## ArevaEPRDCPEm Resource

Attached is a DRAFT response for Question 07.01-35 of RAI No. 505 (FSAR Ch. 7) provided in the attached file in advance of the May 30, 2012 final date.

All indicated changes are in response to RAI 505, 07.01-35

Figure 7.3-48—SBYSE Supply and Recirculation-Exhaust Air Flow Control

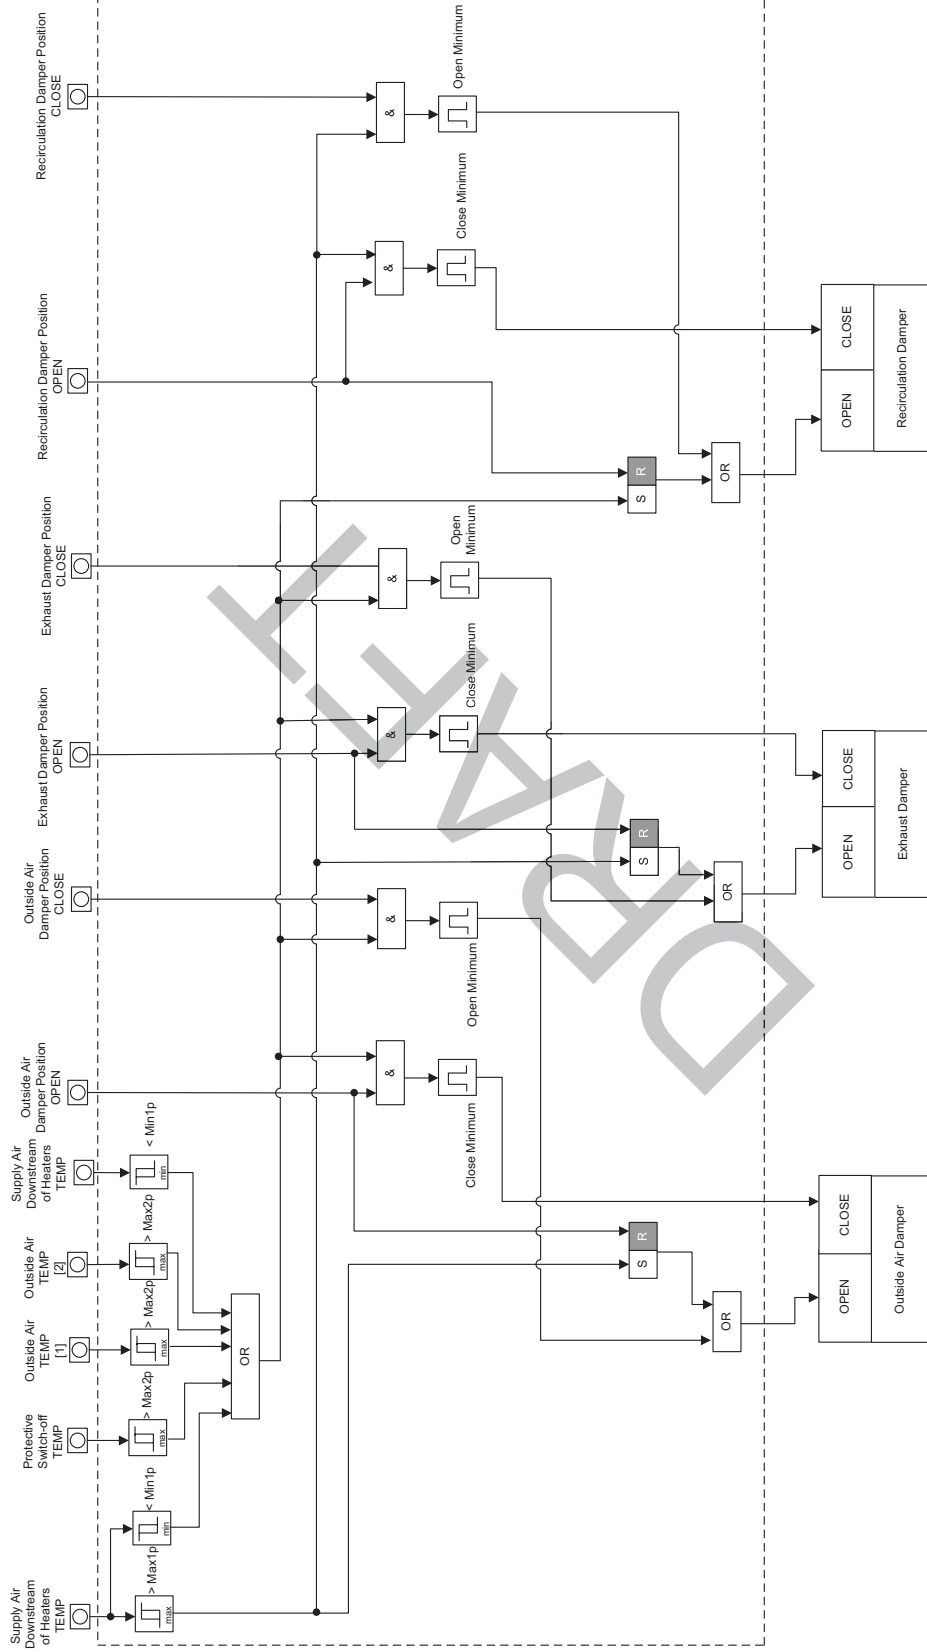
All indicated changes are in response to RAI 505, 07.01-35

Figure 7.3-49—SBVSE Supply Fan Safe Shut-Off

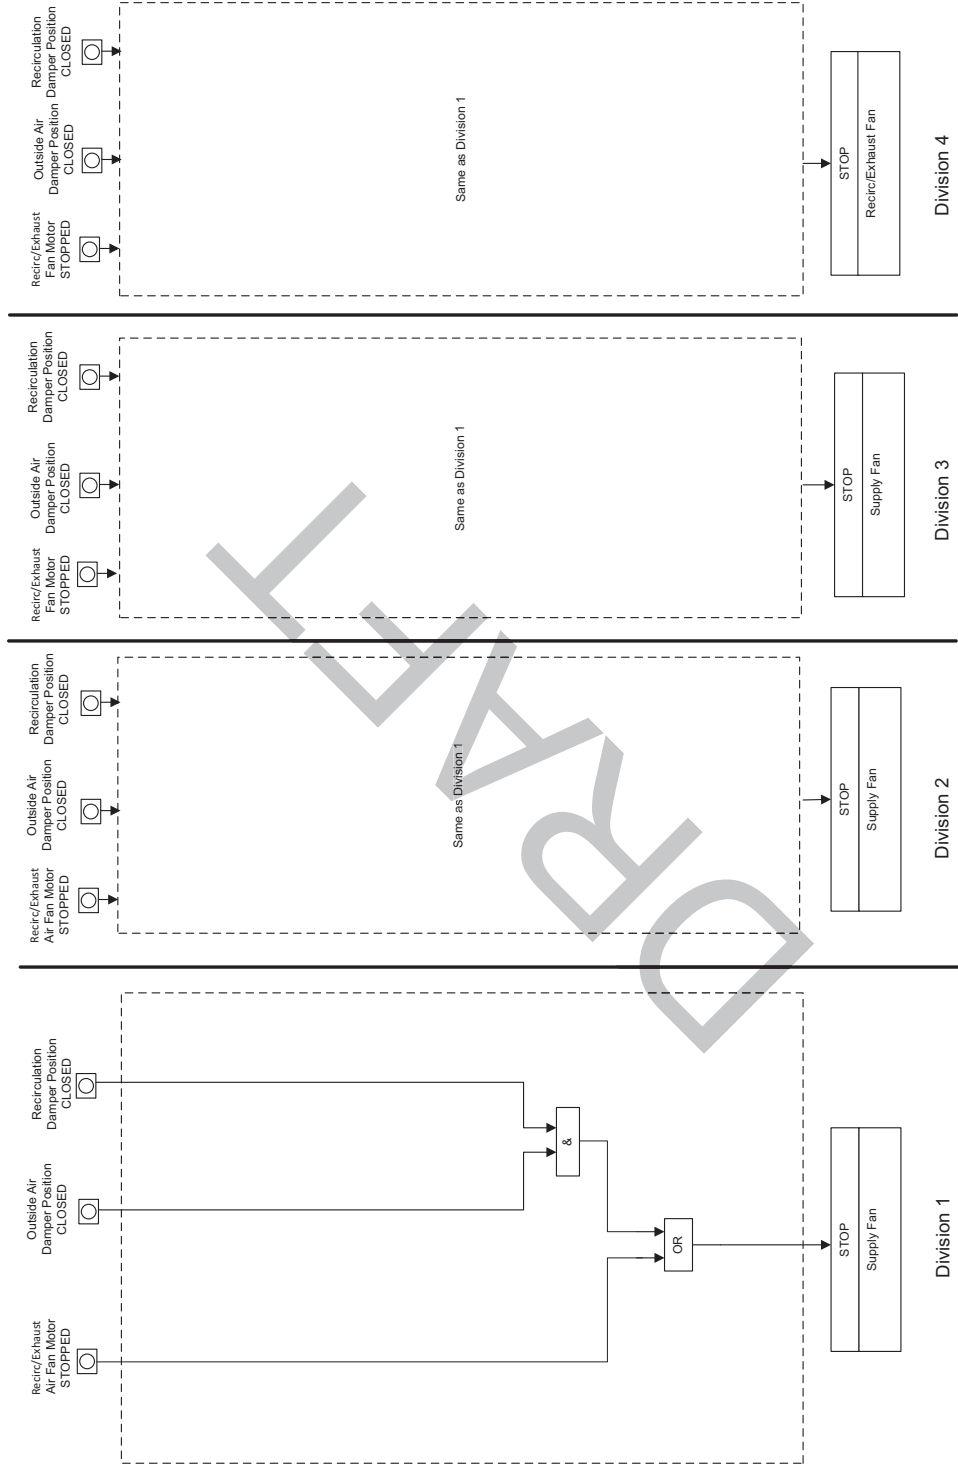
All indicated changes are in response to RAI 505, 07.01-35

Figure 7.3-50—SBVSE Recirculation Fan Safe Shut-Off

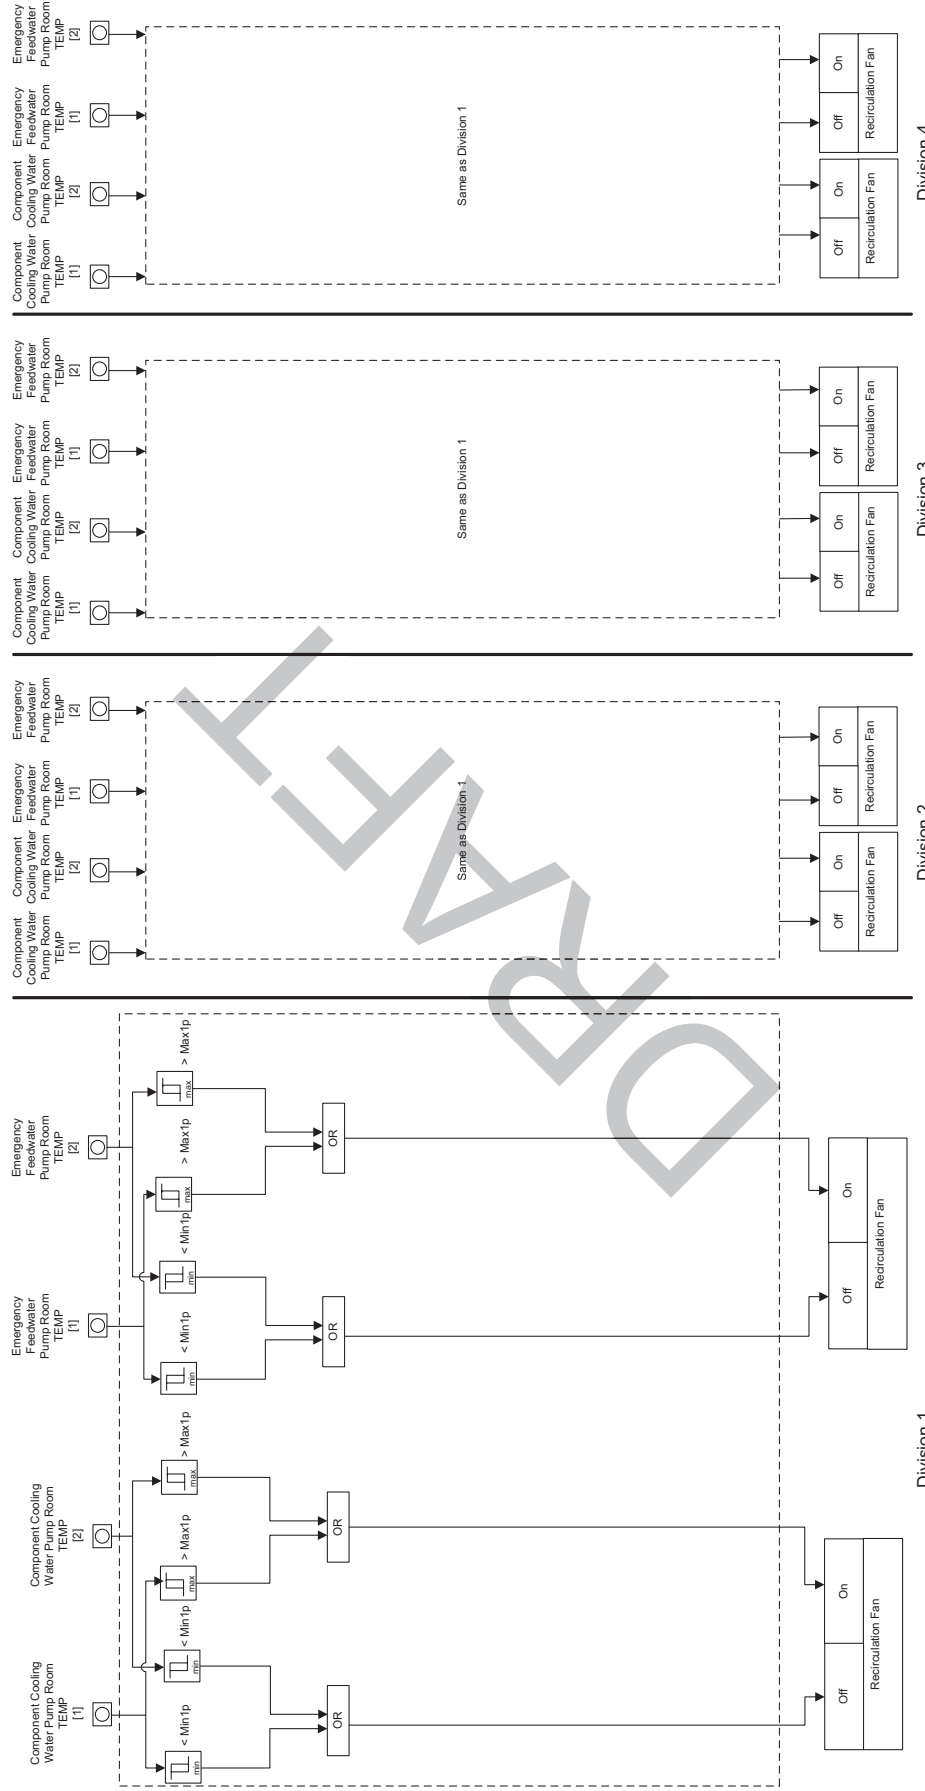
All indicated changes are in response to RAI 505, 07.01-35

Figure 7.3-51—SBVSE Exhaust Fan Safe Shut-Off

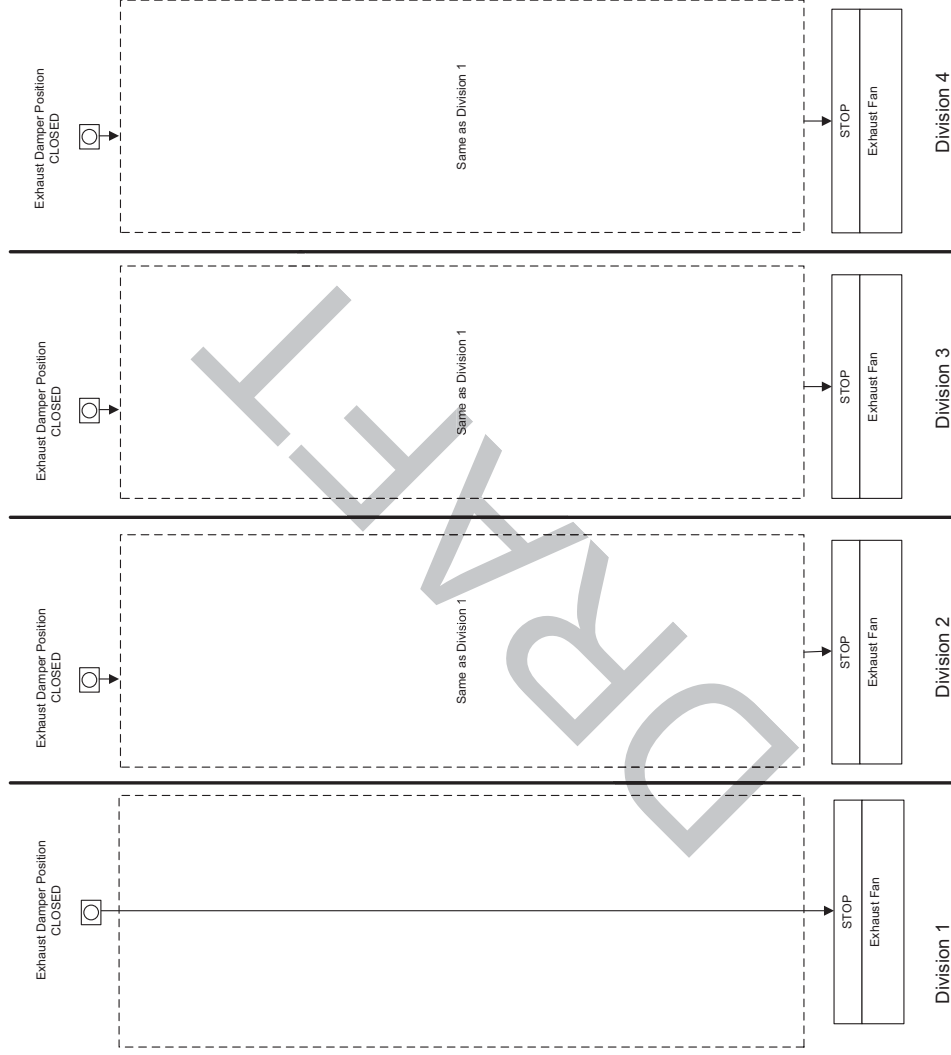
All indicated changes are in response to RAI 505, 07.01-35

Figure 7.3-52—SBVSE Supply Air Temperature Heater Control

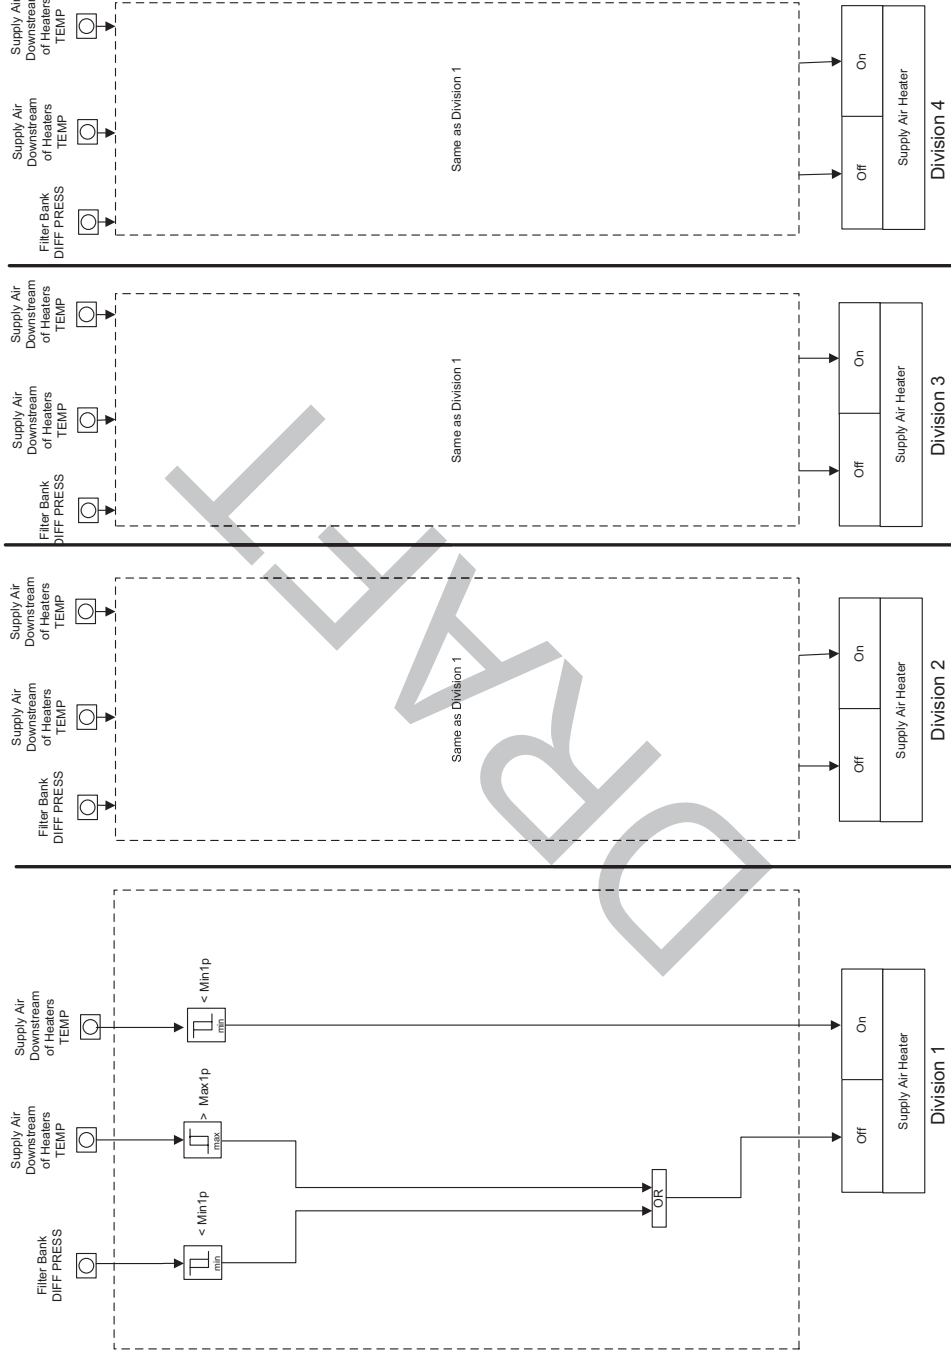
Electrical Division of Safeguard Building Ventilation System (SBVSE)	Supply Air Temperature Heater Control (Figure 7.3-52)	<u>This function is described in Sections 7.3.1.4.6 and 9.4.6. The SBVSE has a safety-related function to ventilate and maintain acceptable ambient temperature in the Safeguard Building areas and rooms ventilated by the system (GDC-4, GDC-17). The Supply Air Temperature function supports this system safety function by maintaining supply air temperature (downstream of heaters) as required to maintain ambient temperature within applicable limits for safety-related equipment located within the Safeguard Building areas and rooms.</u>	NO	N/A	N/A	The I&G associated with the SBVSE is described in Section 9.4.6.

All indicated changes are in response to RAI 505, 07.01-35

Figure 7.3-53—SBVSE Freeze Protection

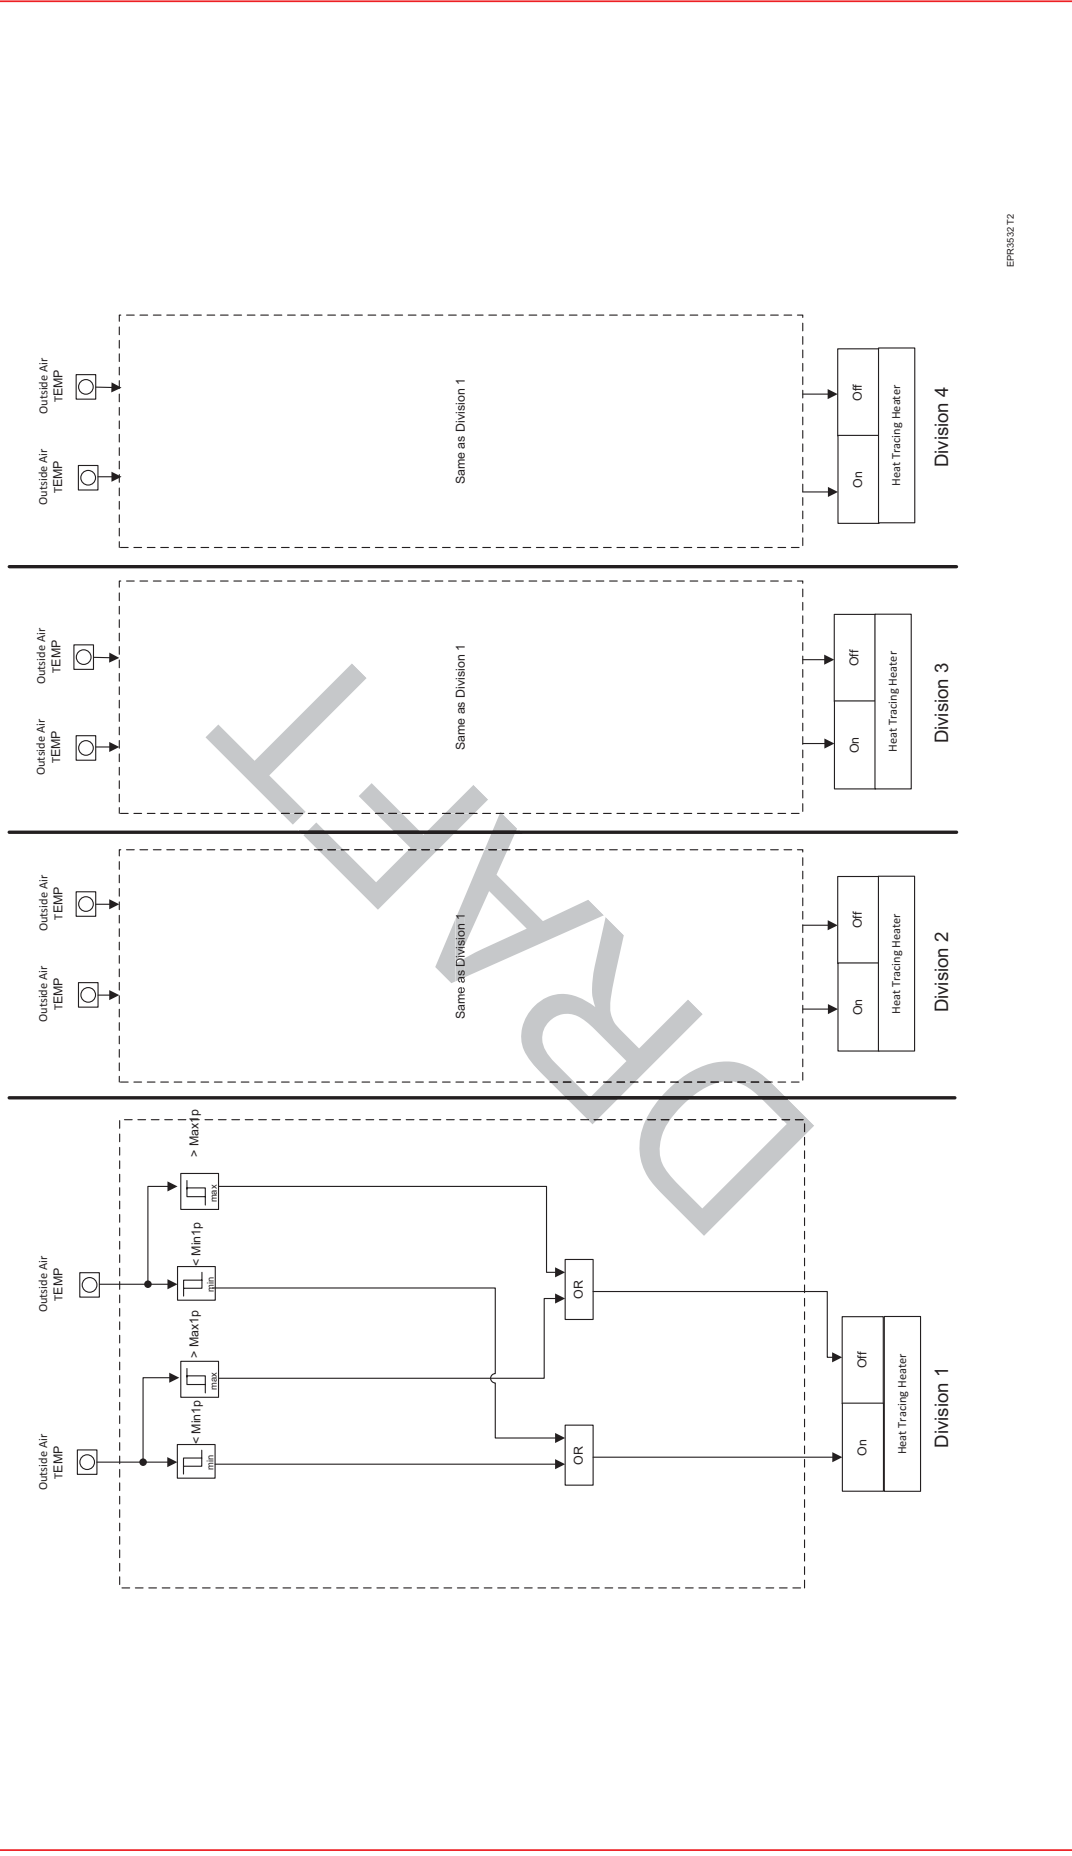
All indicated changes are in response to RAI 505, 07.01-35

Figure 7.3-54—SBVSE Supply Air Temperature Control for Supply Air Cooling

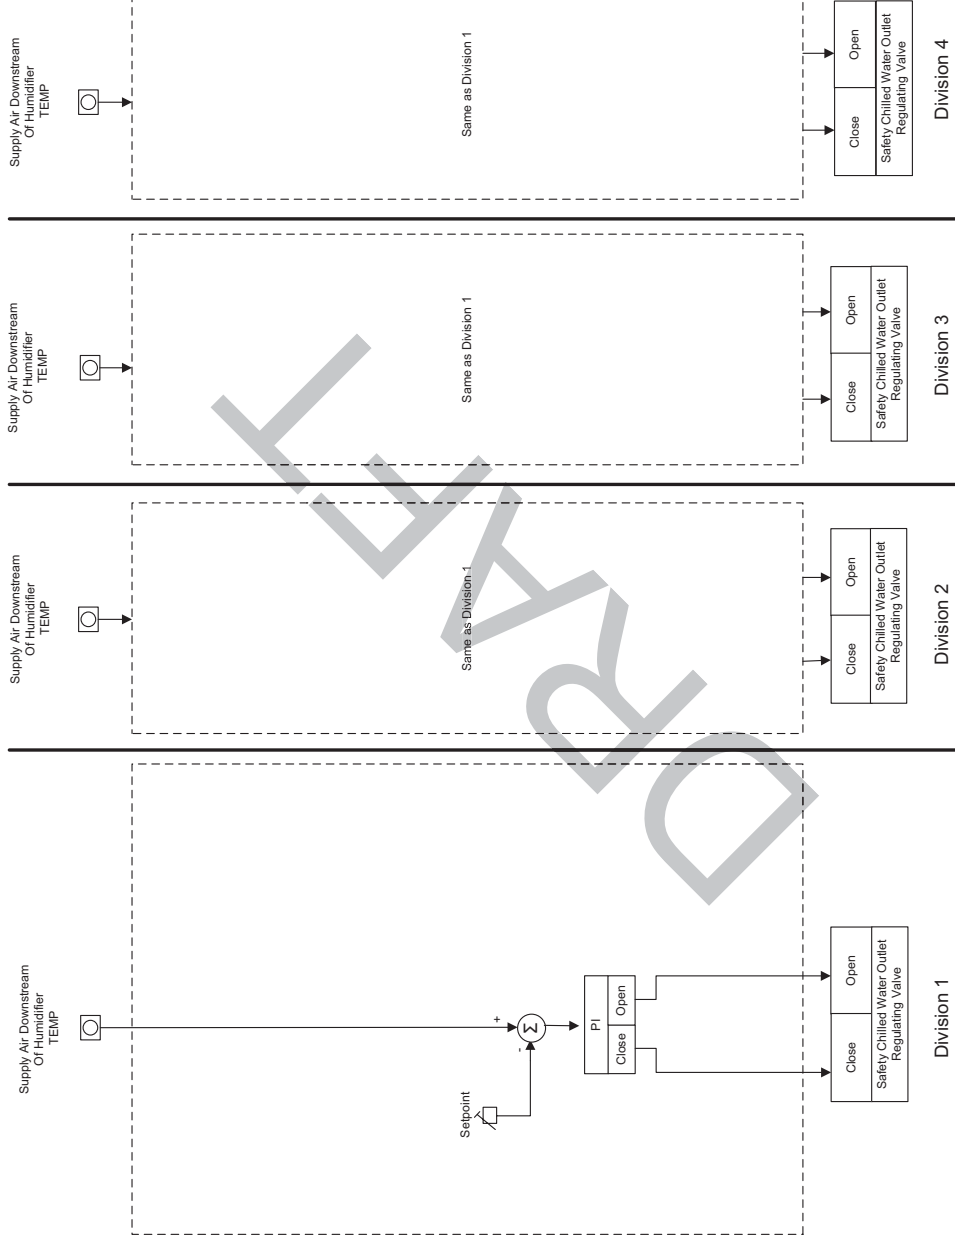
All indicated changes are in response to RAI 505, 07.01-35
